CLARK COUNTY DEPARTMENT OF COMMUNITY DEVELOPMENT DEVELOPMENT SERVICES

STAFF ANALYSIS & RECOMMENDATION

<u>DEVELOPMENT NAME:</u> ENGLISH CONDITIONAL USE PERMIT

CUP2009-00005; PSR2009-00021; SEP2009-00041; CRA2009-00002

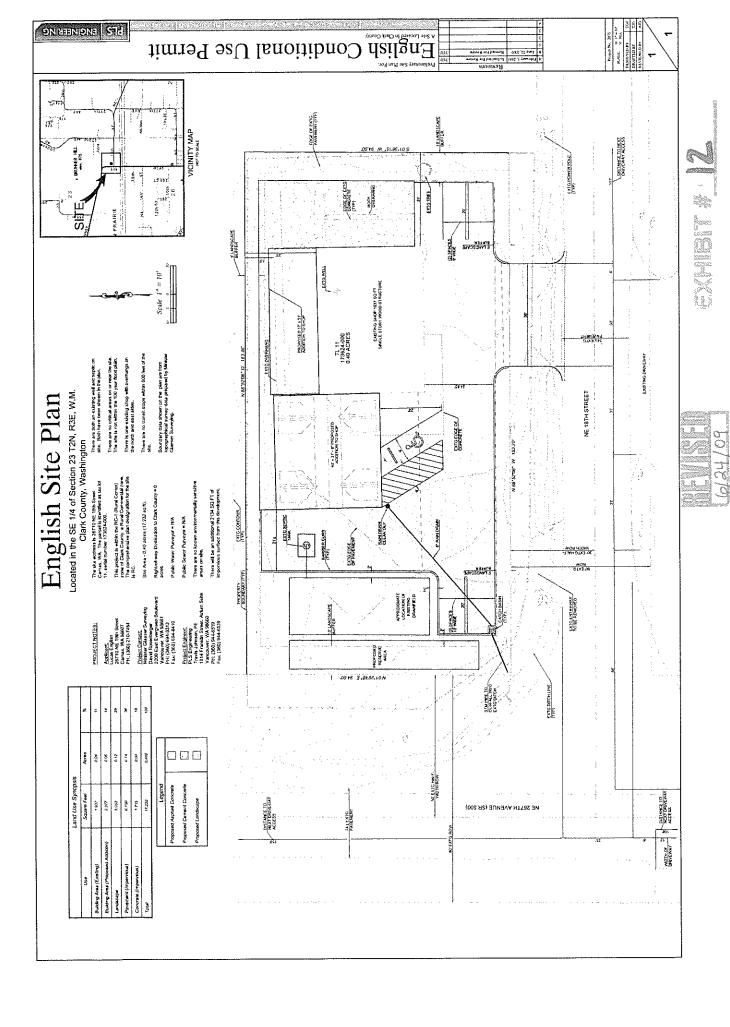
The applicant's revised landscape plan (Exhibit #12) provides the required buffers and plantings, except along the south property boundary, where the plan proposes a 5-foot (rather than 10-foot) buffer with L2 screening and plantings.

The proposed accessible parking space needs to provide an access aisle and an accessible route of travel to the building entrance. (see Condition A-1.a.)

The building elevation and floor plans depict an overhead garage door and vehicle entrance located on the south wall of the west addition. The proposed location of the accessible parking space will conflict with vehicular access to that entrance. (see Condition A-1.b.)

Storage areas for solid waste and recyclables are required in accordance with CCC 40.360. The preliminary site plan does not identify a solid waste enclosure. Therefore, the site plan must be amended. (see Condition A-1.c.)

- A-1 Final Site Plan The applicant shall submit and obtain county approval of a final site plan in conformance to CCC 40.520.040 and the following conditions of approval:
 - a. The site plan shall be amended as necessary to provide an accessible route of travel to the main building entrance from the ADA accessible parking space. (see Finding 5)

- **b.** The site plan shall be amended as necessary to rectify the conflict between the accessible parking space and access to the proposed vehicle entrance into the west building addition. (see Finding 5)

- **c.** The final site plan shall provide a storage area for solid waste and recyclables. The final plans shall provide details of the solid waste enclosure adequate to verify compliance with the size and design standards in CCC 40.360. (see Finding 6)
